Title PCal Photodiode Head			
Size: B	DCC Number: D1300210	Ligo Project California Institute of Technology Massachusetts Institute of Technology	
Drawn by: Ben Abbott	Date: 11/2/2018	Revision: v5	Cannot open file C:\Restored\Ben\miscellany\ligo\go_t.jpg
File: C:\Users\marc.pirello\Desktop\D1300210-v5\PCalPDv5.SchDoc		Time: 1:11:29 PM	Sheet 1 of 1

PCa1_PD
D1300210-v5

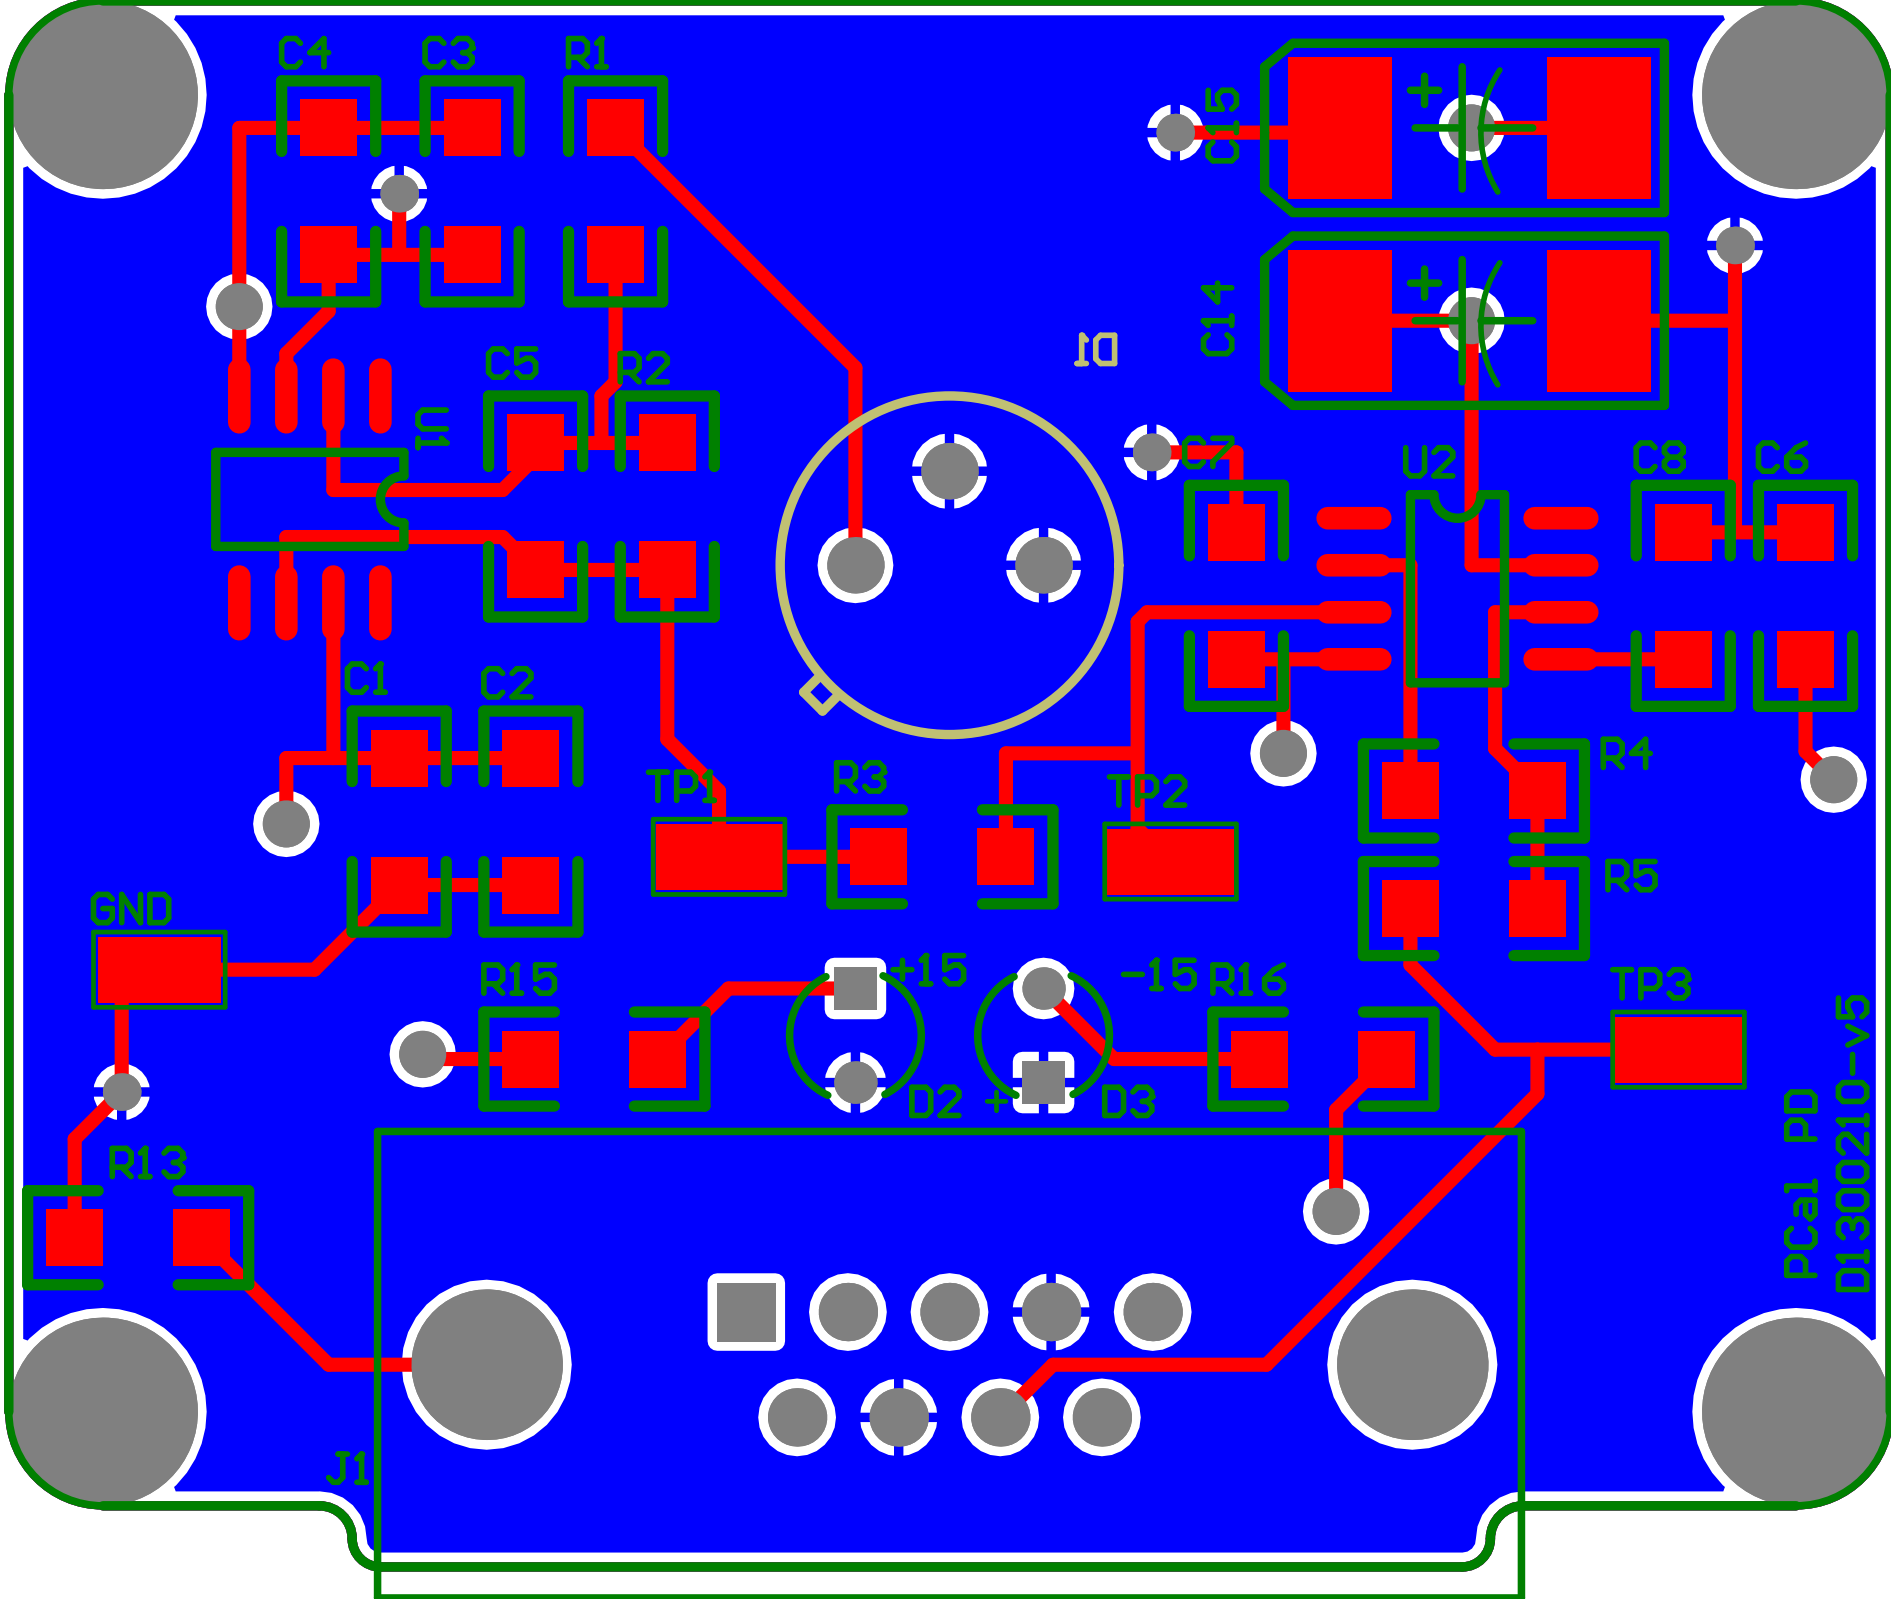
rev. v3 changes U1 & U2 to AD829s for high slew rate.

rev. v4 adds R17, R18, R19, for bias current balancing, and C16, and C17 to the pcb for OpAmp compensation.

rev. v5 Removed U2 and U4. Resistor R5 added on output of U2.
